BARANGAROO SOUTH

Stage 1B Public Domain Modification S4.55 Development Application Report

Mod Application Overview

BARANGAROO AVENUE MASTERPLAN

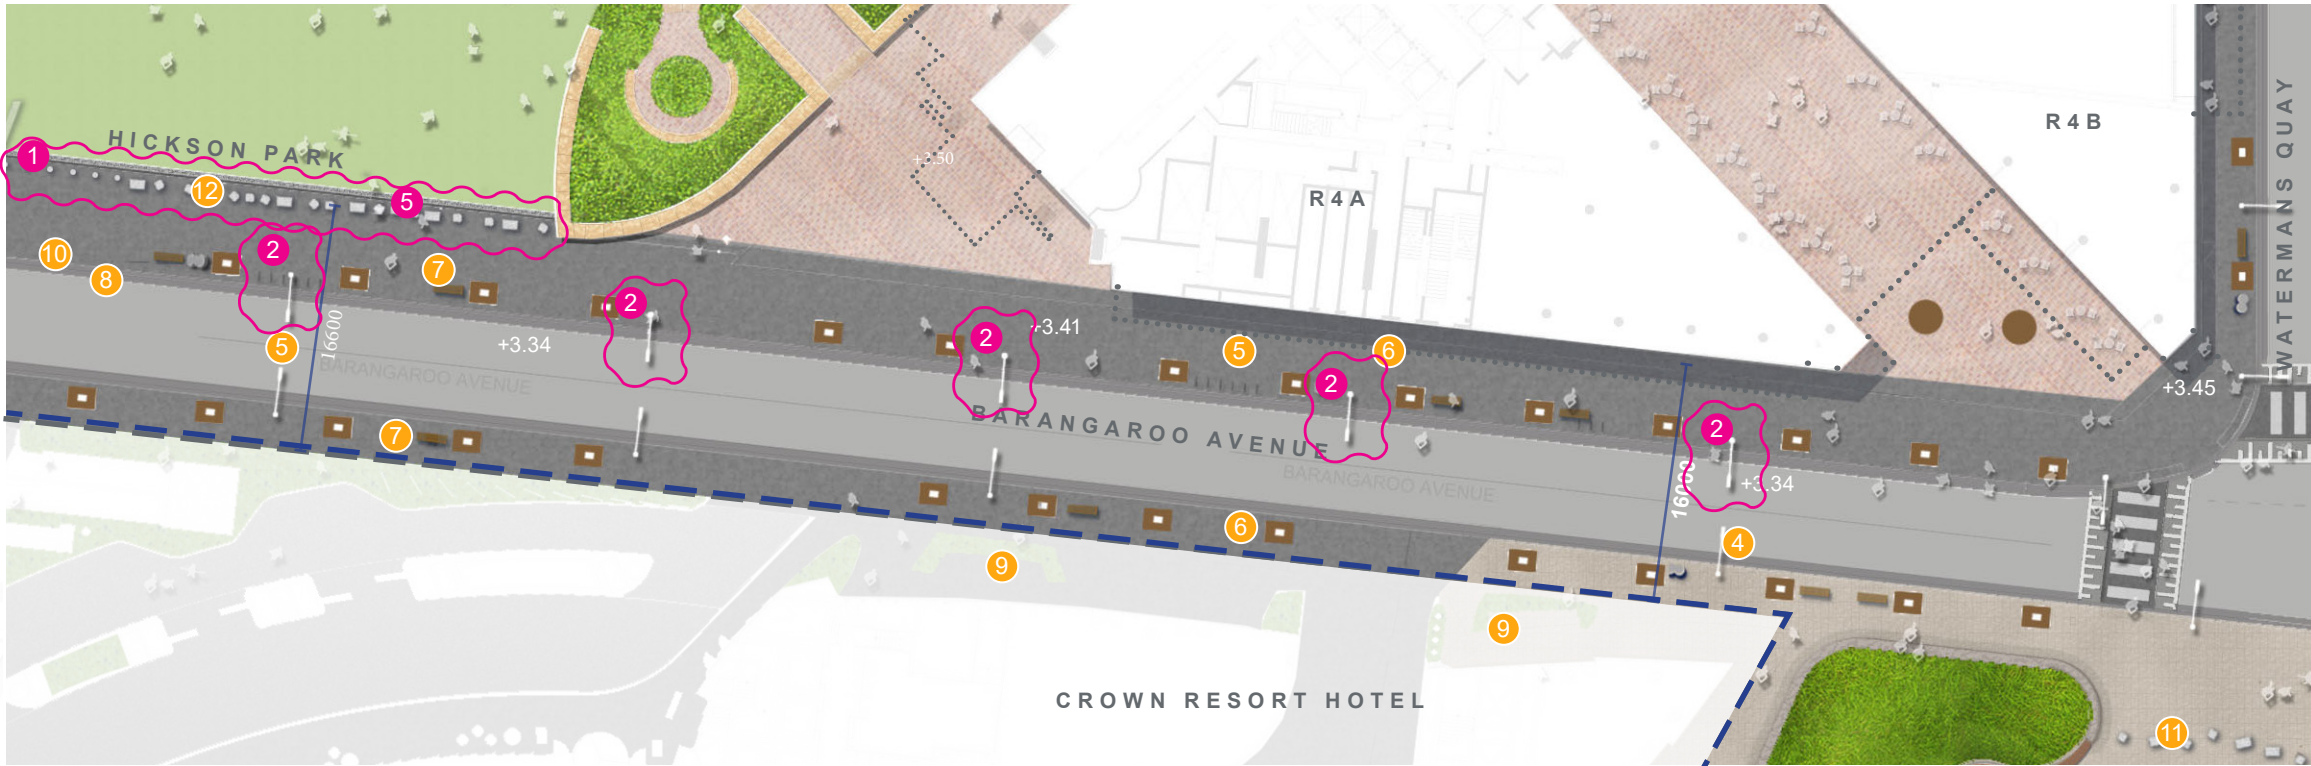
- Amendment cloud
- 1 Sandstone paving strip changed to City of Sydney paving along Hickson Park
- 2 Additional smart pole
- 3 Relocated Fig tree to North raised planter
- 4 Not in use
- 5 Sandstone bollards changed to concrete & setout amended.

BARANGAROO AVENUE NORTH
DETAIL PLAN

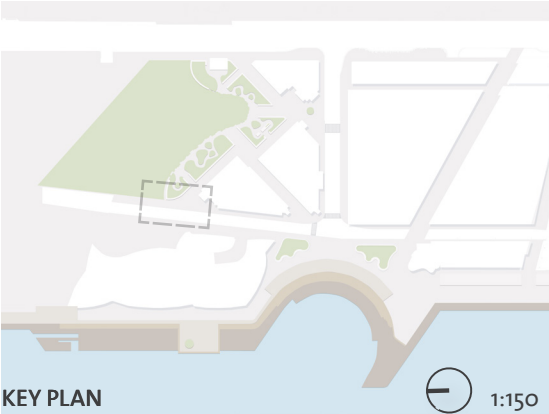
- Amendment cloud
- 1 Sandstone paving strip changed to City of Sydney paving along Hickson Park
- 2 Sandstone bollards changed to concrete & setout amended.
- 3 Remove porphyry paving to City of Sydney transition as per consent requirement B23
- 4 Additional smart pole

BARANGAROO AVENUE SOUTH
DETAIL PLAN

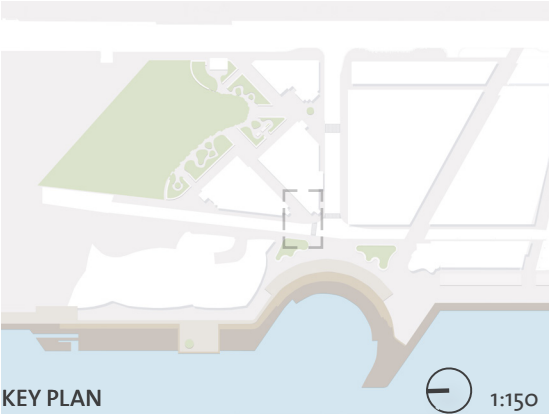
- Amendment cloud
- 1 Additional smart pole
- 2 Not in use
- 3 Relocated Fig tree to North raised planter

HICKSON PARK EAST ENTRY
DETAIL PLAN

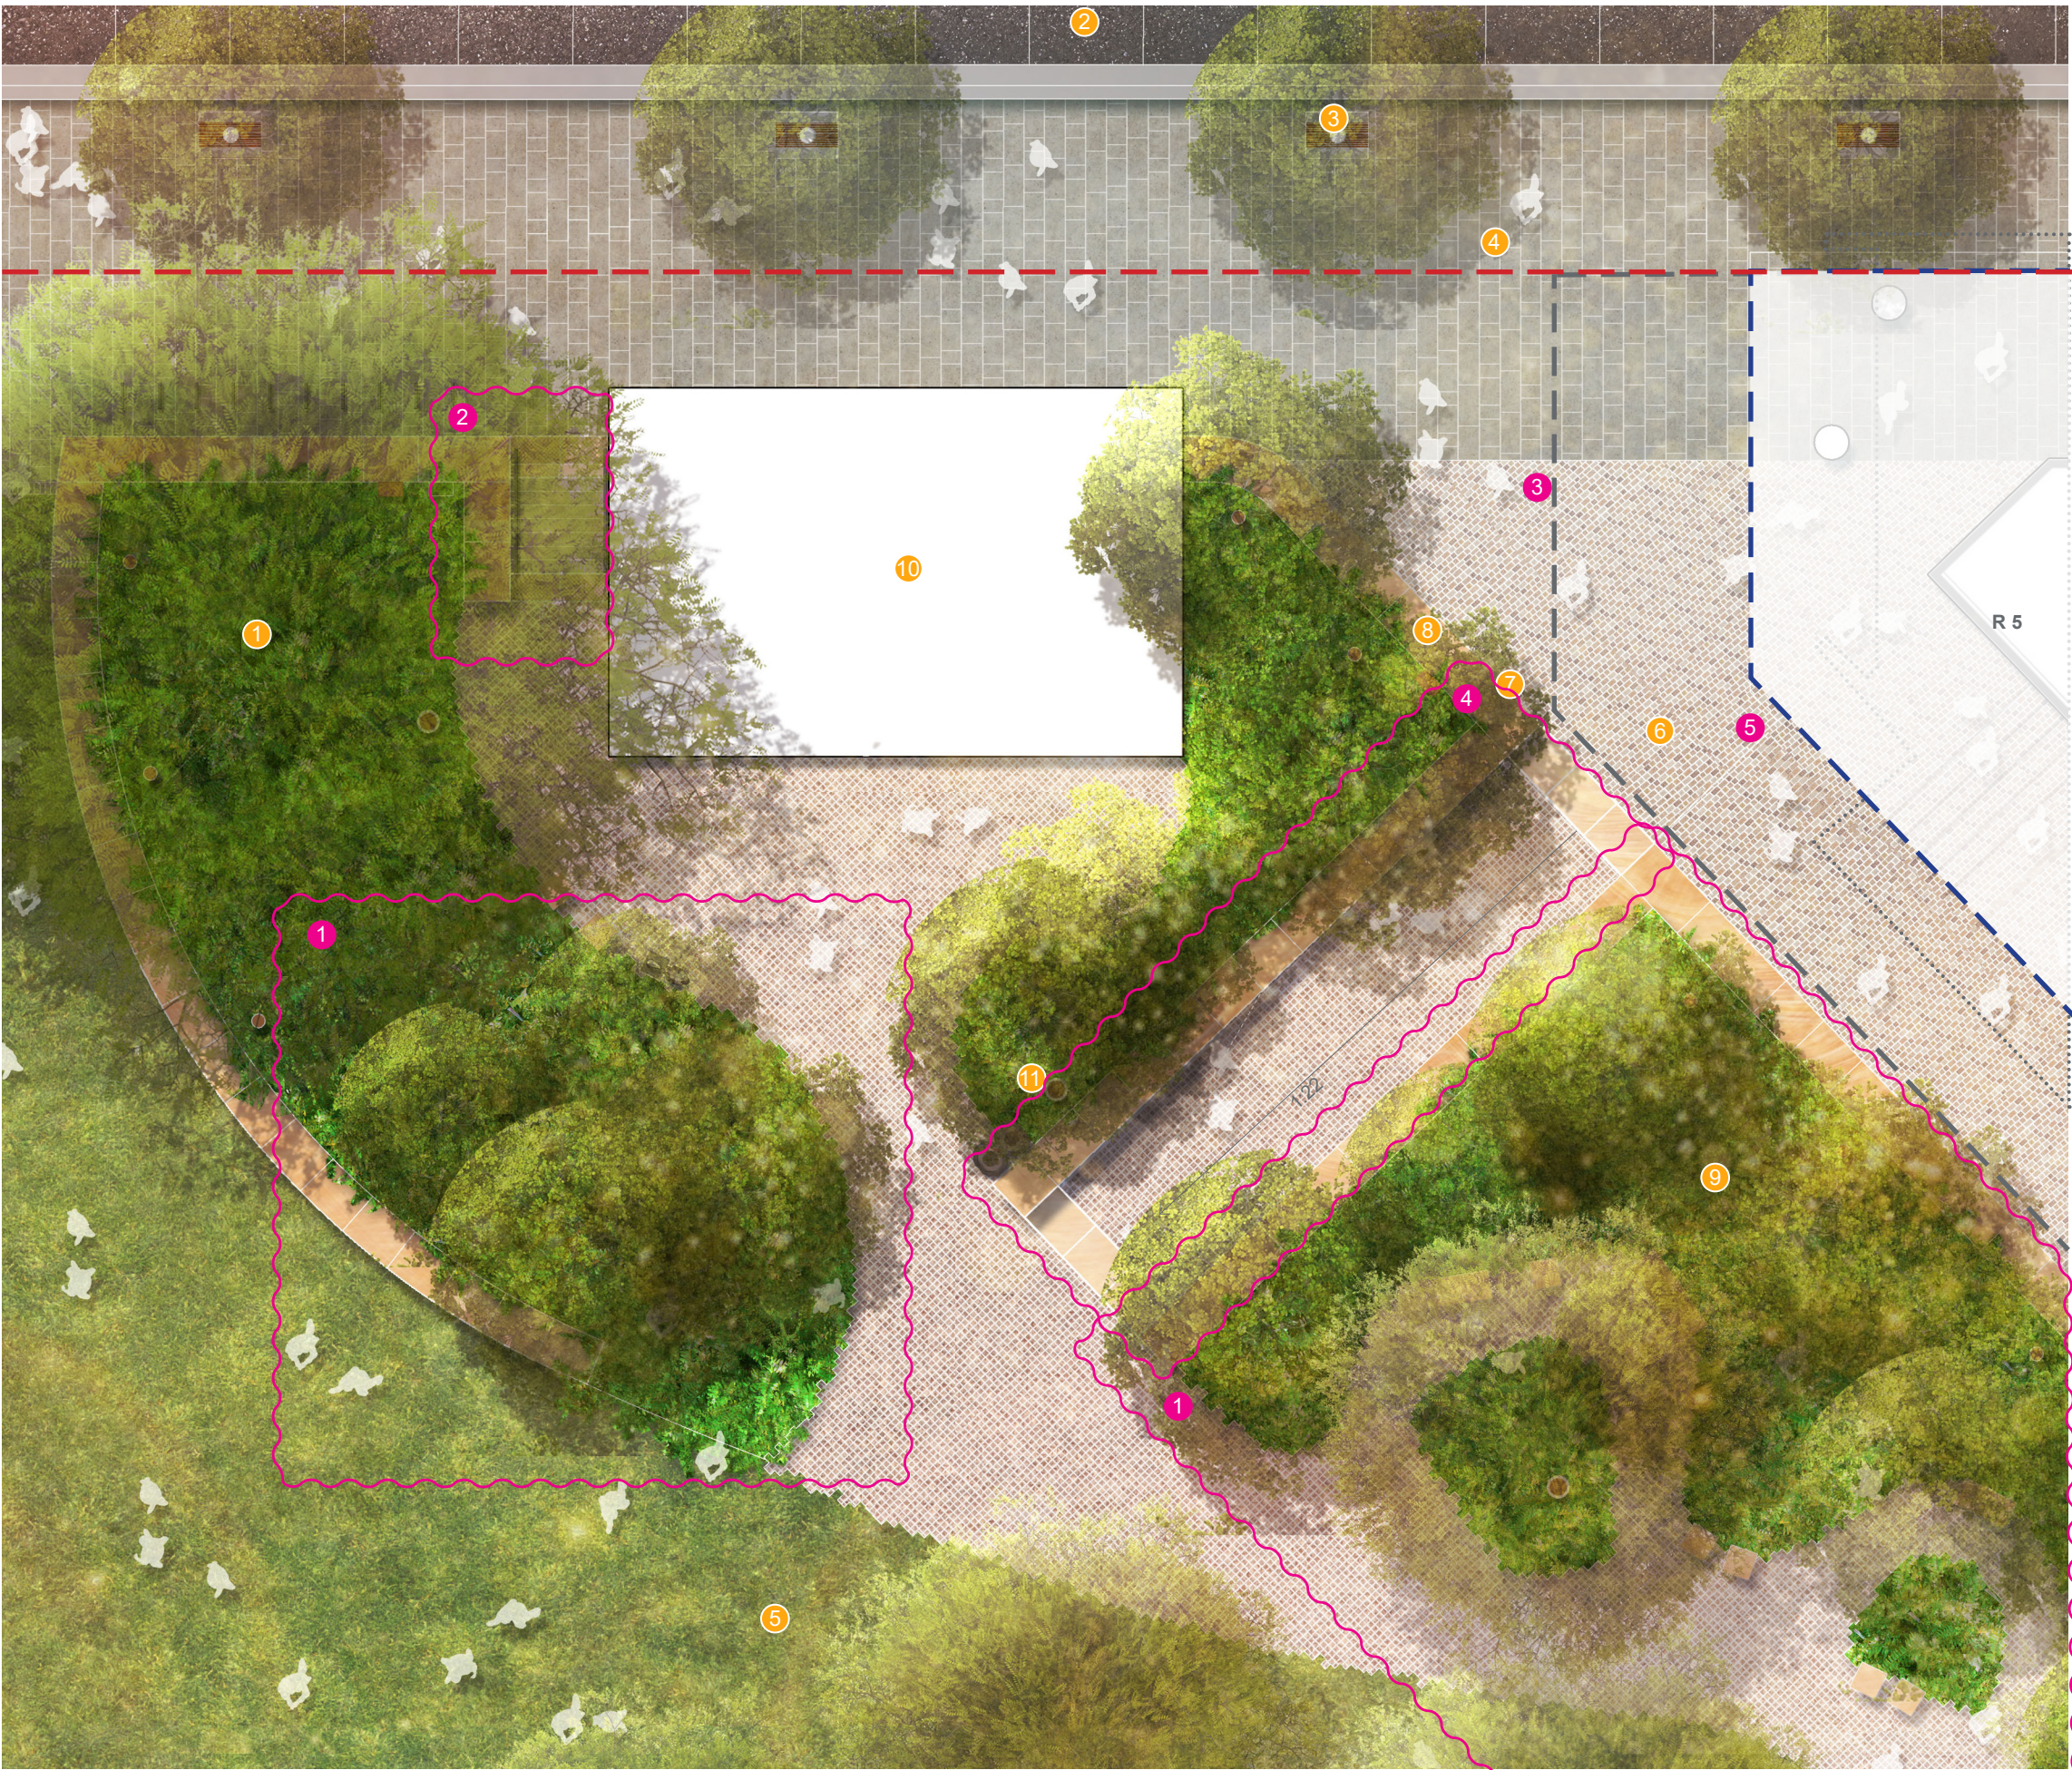
- Amendment cloud
- 1 Increase planting area within the park, change of geometry
- 2 Stone stairs changed to concrete
- 3 Remove porphyry paving to City of Sydney transition as per consent requirement B23
- 4 Shallower ramp, remove handrail, landing, and tactile tiles due to proposed Hickson Road levels
- 5 Remove ramp and sandstone wall due to proposed Hickson Road levels

HICKSON PARK EAST ENTRY
DETAIL PLAN

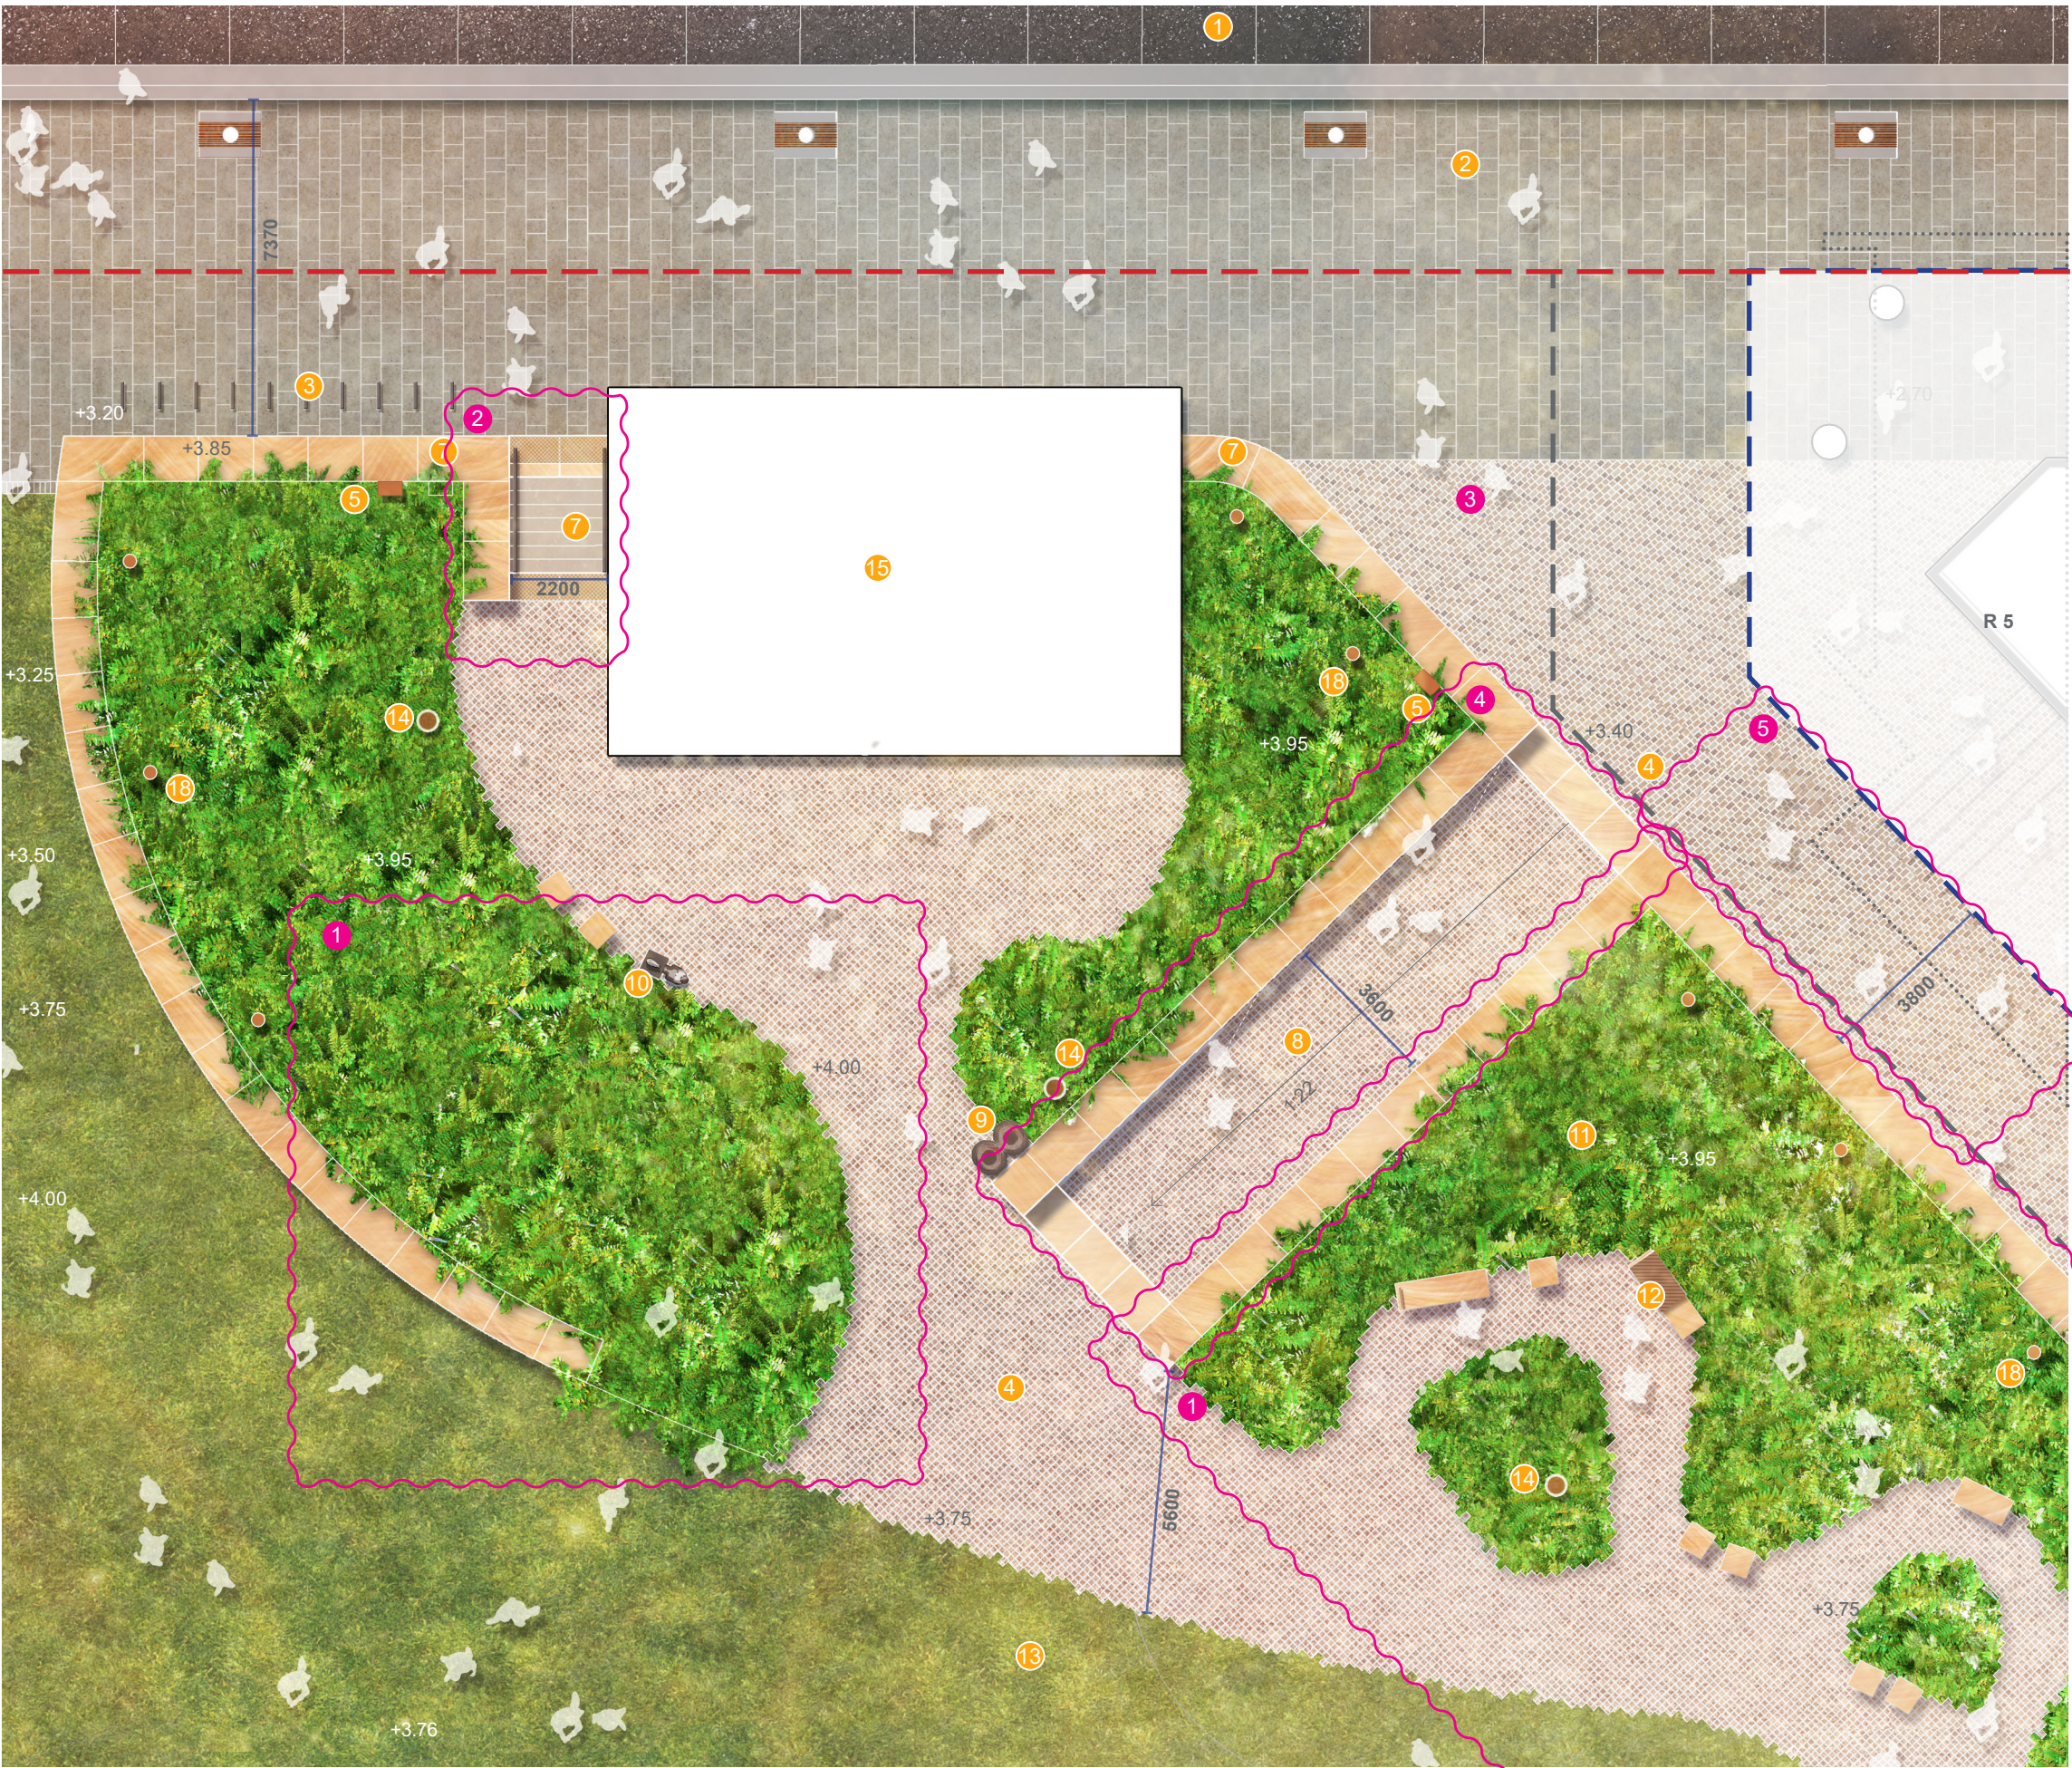
- Amendment cloud
- 1 Increase planting area within the park, change of geometry
- 2 Stone stairs changed to concrete
- 3 Remove porphyry paving to City of Sydney transition as per consent requirement B23
- 4 Shallower ramp, remove handrail, landing, and tactiles due to proposed Hickson Road levels
- 5 Remove ramp and sandstone wall due to proposed Hickson Road levels
